Location of Construction: 28 Stuart Street	Owner: James Higgins	Phone: ***797-5360	Permit No: 991362
Owner Address:	Lessee/Buyer's Name:	Phone:	Permit issued: JUL 10 1999
Contractor Name: R & G Remodling	Address: Maple Street	Phone: 797-5694	CITY OF PORTLAND
Past Use: Vacant land	Proposed Use: single family home with attached garage		
Proposed Project Description: Single family home w/ attached X garage	Signature: [Signature]	PEDESTRIAN ACTIVITIES DISTRICT (P.A.D.)	Zone: CBL: 337-C-015
Permit Taken By: nbw	Date Applied For: 29, October 1999	Action: Approved with Conditions: <input type="checkbox"/> Approved <input type="checkbox"/> Denied <input type="checkbox"/>	Zoning Approval: Special Zone or Reviews: <input type="checkbox"/> Shoreland <input type="checkbox"/> Wetland <input type="checkbox"/> Flood Zone X - paid 10/19/99 <input type="checkbox"/> Subdivision <input type="checkbox"/> Site Plan maj <input type="checkbox"/> minor <input type="checkbox"/>

RE: Certificate of Occupancy - 28 Stuart Street

RE: Limited Site Plan
Lot 2- Stuart Street
Portland, Maine
Project No. 1-000047.00

**CITY OF PORTLAND, ME
BOCA 1996 Plan Review Record
One and Two Family Dwelling**

TITLE:
 LIMITED SITE PLAN
 LOT 2, STUART STREET
 CITY OF PORTLAND
 CUMBERLAND COUNTY

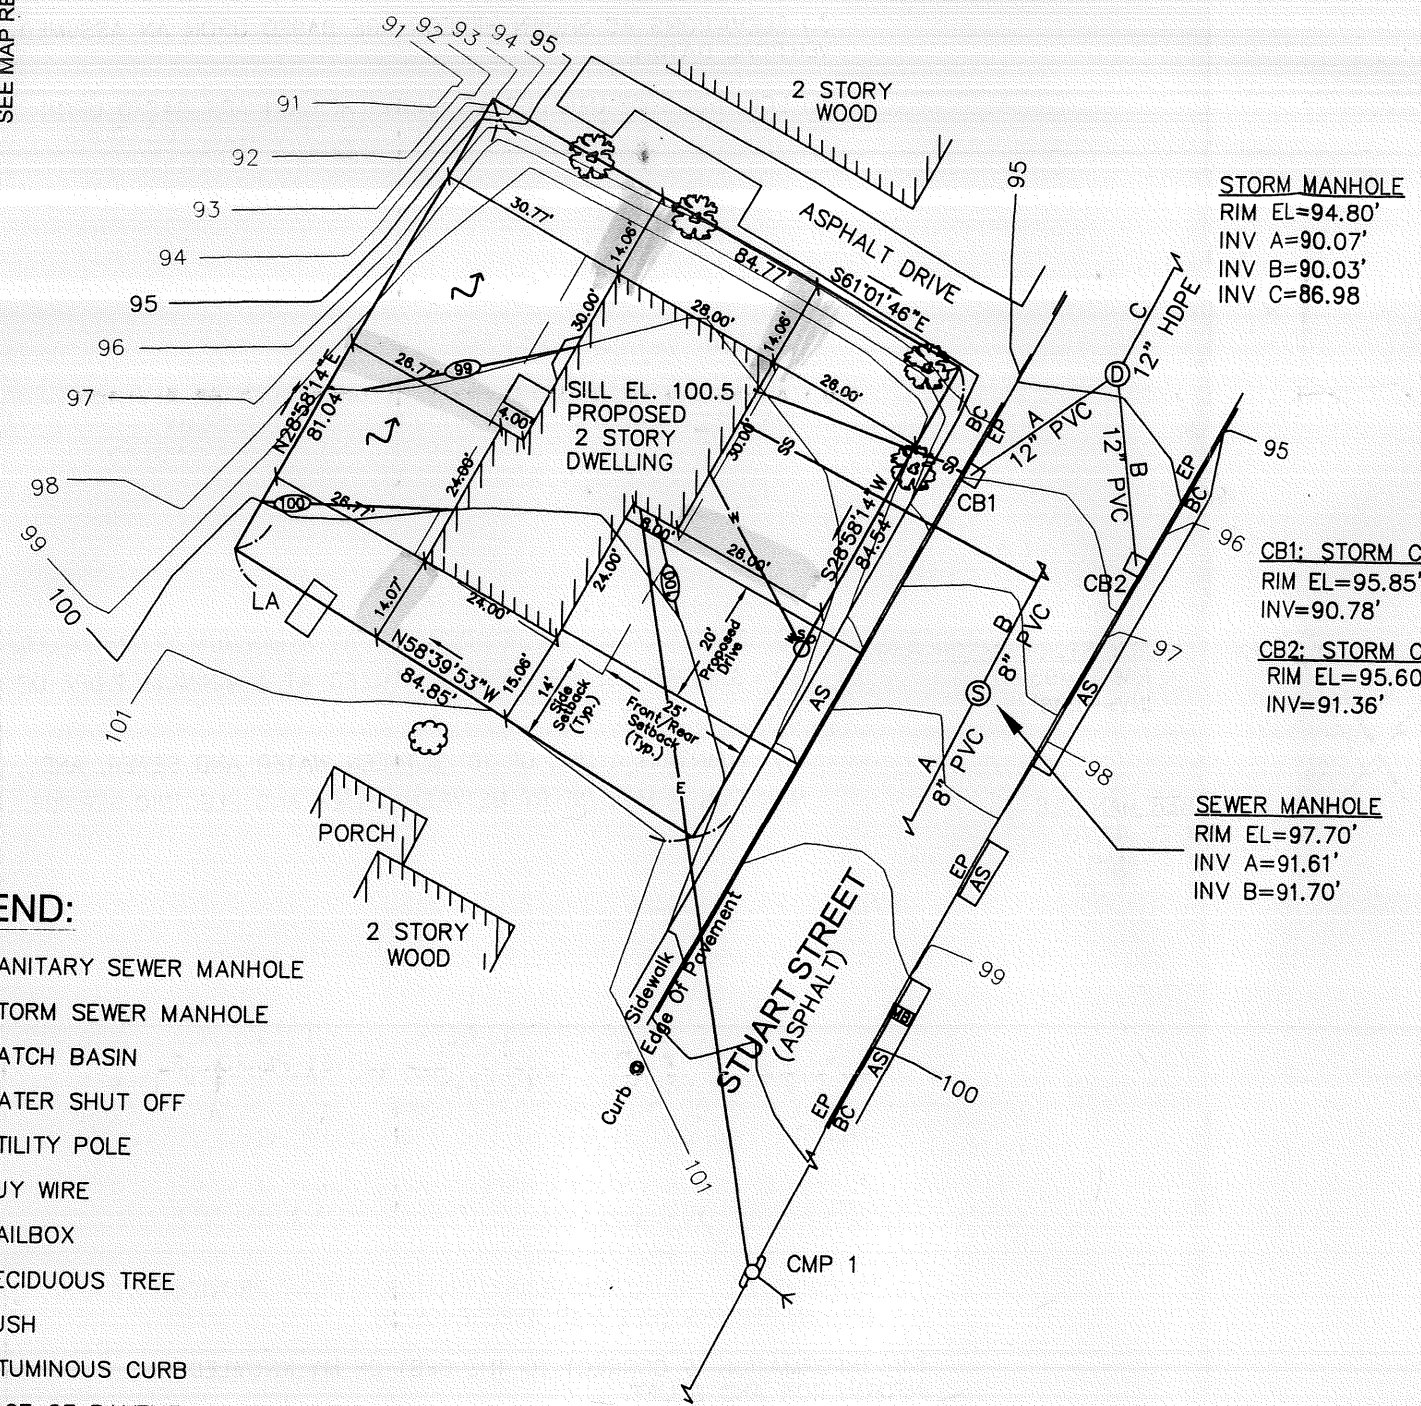
1. PLANIMETRIC & TOPOGRAPHIC DETAIL SHOWN HERE IS A RESULT OF AN ON-THE-GROUND FIELD SURVEY PERFORMED BY SURVEY & GEODETIC CONSULTANTS, INC. DECEMBER 3, 1999. AT THE TIME OF THE SURVEY THE LOT HAD BEEN CLEAR GRUBBED AND THE FOUNDATION WAS IN THE PROCESS OF BEING EXCAVATED.
2. PROPERTY LINES SHOWN HEREON WERE COMPILED FROM MAP REFERENCE 1 AND ARE NOT THE RESULT OF A STANDARD BOUNDARY SURVEY.
3. PROPOSED HOUSE FOOTPRINT FROM SITE PLAN PROVIDED BY MR. JIM HIGGINS (SEE MAP REFERENCE 2).
